Model: Model AT-C1	Date: 29-May-06	No.: RB230001j
--------------------	-----------------	----------------

Subject: Firmware Release History (Engine)		Prepared by: H. Tamaki	
From: 1st Overseas Tech Support Sec., 1st PQM Dept.			
Classification:	<input type="checkbox"/> Troubleshooting	<input type="checkbox"/> Part information	<input type="checkbox"/> Action required
	<input type="checkbox"/> Mechanical	<input type="checkbox"/> Electrical	<input type="checkbox"/> Service manual revision
	<input type="checkbox"/> Paper path	<input type="checkbox"/> Transmit/receive	<input type="checkbox"/> Retrofit information
	<input type="checkbox"/> Product Safety	<input checked="" type="checkbox"/> Other ()

Model: Model AT-C1		Date: 15-Sep-06	No.: RB230015
Subject: Service Manual Correction		Prepared by: H. Someya	
From: 1st Tech. Support Sec. Service Support Dept.			
Classification:	<input type="checkbox"/> Troubleshooting	<input type="checkbox"/> Part information	<input type="checkbox"/> Action required
	<input type="checkbox"/> Mechanical	<input type="checkbox"/> Electrical	<input checked="" type="checkbox"/> Service manual revision
	<input type="checkbox"/> Paper path	<input type="checkbox"

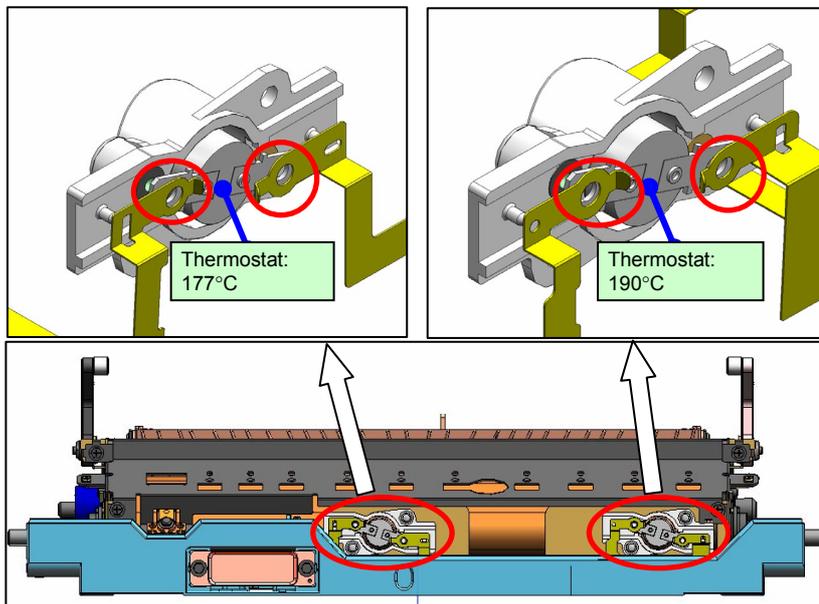
Make sure to do the following when you replace the thermostats.

- Attach the thermostat under the electrode plates.

- Attach the thermostat that is marked **green** at the **middle** position. Attach the thermostat that is **not marked** at the **rear** position.

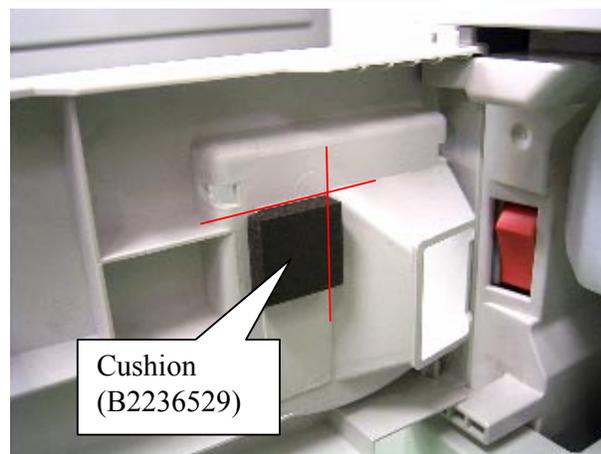
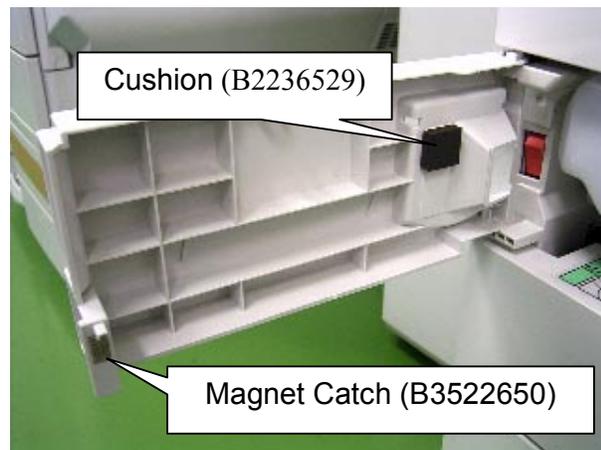
The low temperature causes the toner bottle to contract (shrink) slightly. As a result, sometimes the toner bottle does not touch the "toner bottle set switch".

Attach a cushion to the front door and replace the magnet catch.

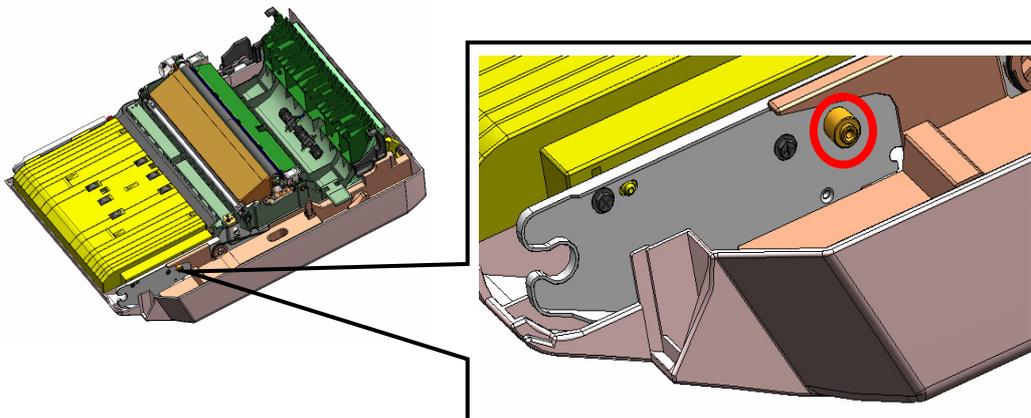
The following parts connecting the mainframe and duplex unit may break:

- The duplex link and/or peen on the mainframe
- The peen on the duplex unit

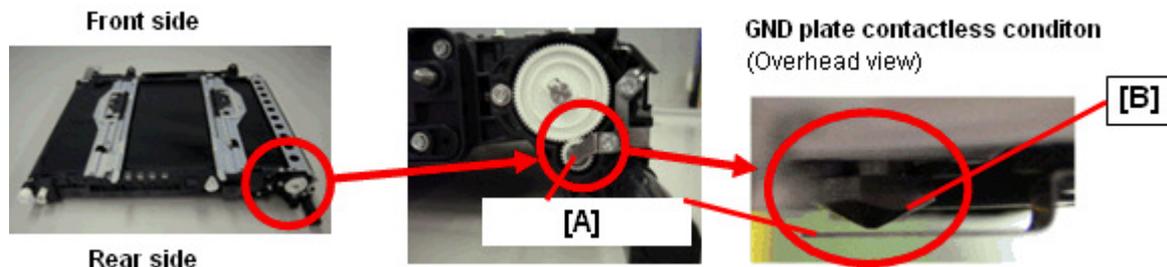
Sometimes, the GND plate at the rear side of the ITB cleaning unit [A] does not touch the lubrication application shaft [B]. As a result, a minor electrical leak occurs, which can trigger electrical noise. Sometimes, this effect appears as lines at 110mm intervals.

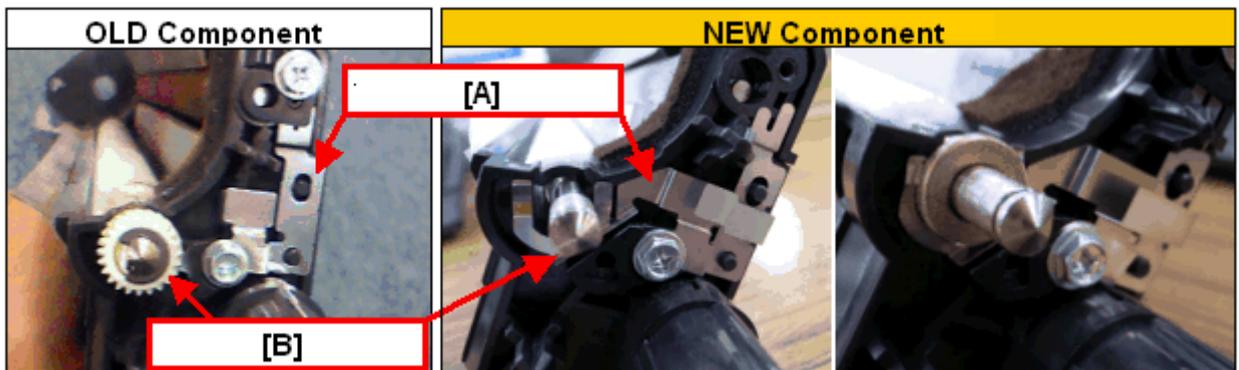
- The shape of the GND plate [A] was changed so that there is another contact point between the GND plate and the lubricant application shaft [B].

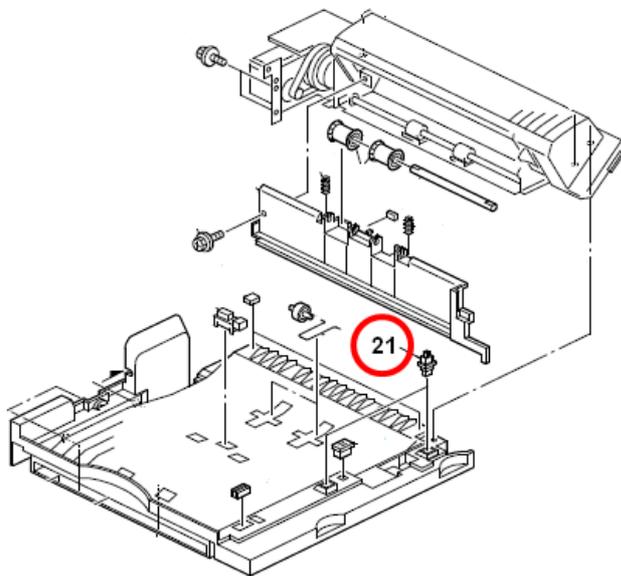
Jam 1 (Cover open) occurs frequently in the BU3000 Bridge unit.
 If you replace the push switch in the red circle below, this symptom still occurs.

Areas of the PCU that have changed in shape:
The old and new units are completely interchangeable (O/O).

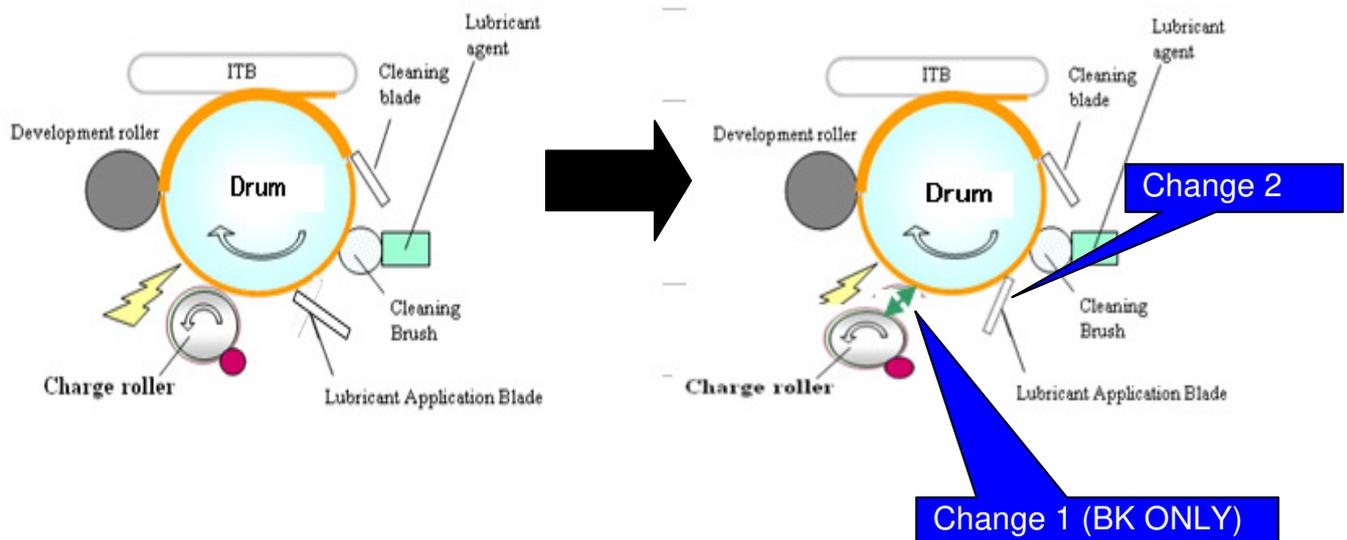
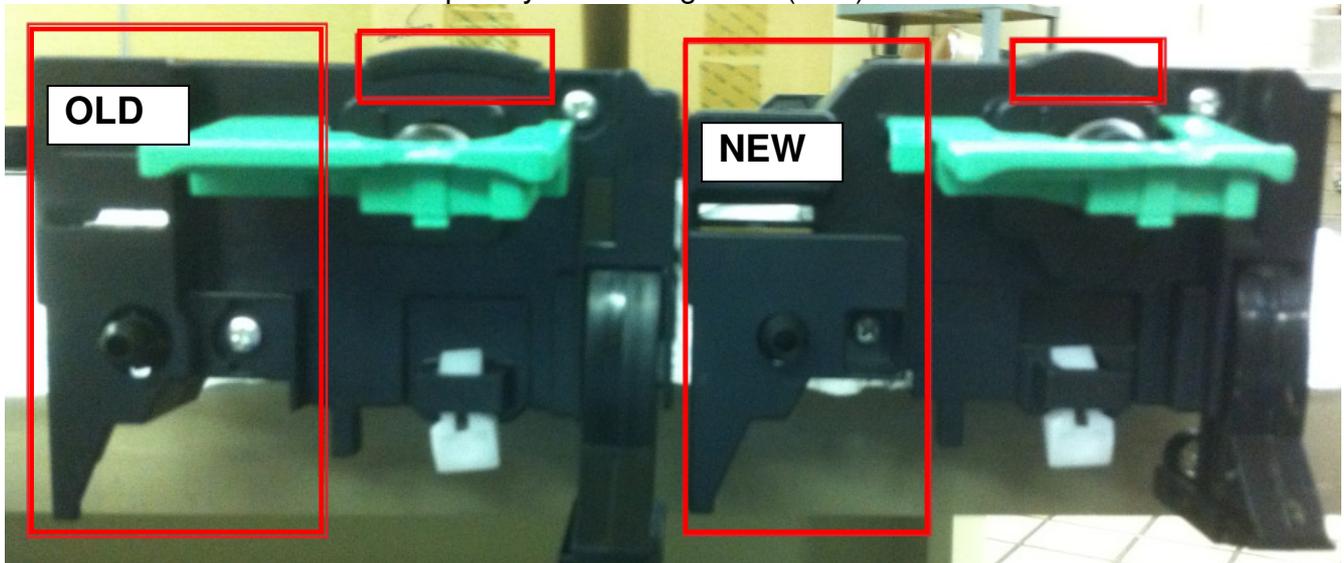
Old part number	New part number	Description	Q'ty	Int	Page	Index
B2232042	B2242042	DRUM UNIT BK	1	O/O	47	4
B2232027	B2242027	DRUM UNIT CL	1	O/O	47	4
